Access Compliance Report

Public Rights-of-Way

Intersection ID: 53629	Main Street: CAMBRIDGE_FOREST_CT	Cross Street: PROVIDENCE_RD_WEST	Location: SW
ADA ID: E2A3B3AB527B	Ramp Type: PerpDiag	Initial Pass/Fail: Fail	Overall Compliance: No
Severity Score: 10			
Codes/Mitigation Info/Possible Solution		Field Measurements/Component Compliance

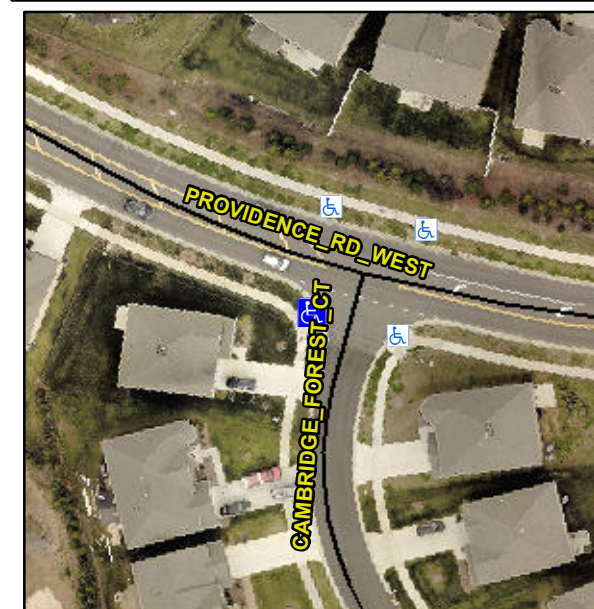
Not Found, R304.5.1, R304.5.3

Compliance	Description	Data	Compliance	Description	Data
N/A	Ramp Length (in)	95.0	Yes	Ramp Slope (%)	5.5
No	Ramp Width (in)	46.0	No	Ramp XSlope (%)	3.8
N/A	Flare Type LT	N/A	N/A	Flare Type RT	N/A
N/A	Flare Slope LT (%)	N/A	N/A	Flare Slope RT (%)	N/A
N/A	Flare Traversable LT?	N/A	N/A	Flare Traversable RT?	N/A
N/A	Landing Length (in)	N/A	N/A	DWS Provided?	N/A
N/A	Landing Width (in)	N/A	N/A	DWS Contrast?	N/A
N/A	Landing Slope (%)	N/A	N/A	DWS Length (in)	N/A
N/A	Landing X Slope (%)	N/A	N/A	DWS Full Width?	N/A
N/A	Landing Curb? (Y/N)	N/A	N/A	DWS Offset (in)	N/A
N/A	Shared Landing?	N/A			
N/A	Gutter Ponding?	N/A	N/A	Gutter Slope (%)	N/A
N/A	Gutter Lip Ht (in)	N/A	N/A	Gutter X Slope (%)	N/A
N/A	Painted X Walk1?	No	N/A	Painted X Walk2?	No
	X Walk 1 Direction	To SE		X Walk 2 Direction	To NE
N/A	X Walk 1 Width (in)	N/A	N/A	X Walk 2 Width (in)	N/A
	X Walk 1 Slope (%)	0.1		X Walk 2 Slope (%)	4.9
	X Walk 1 X Slope (%)	2.6		X Walk 2 X Slope (%)	1.4

Remove & Replace Curb Ramp With Two New Directional Ramps or Equivalent.
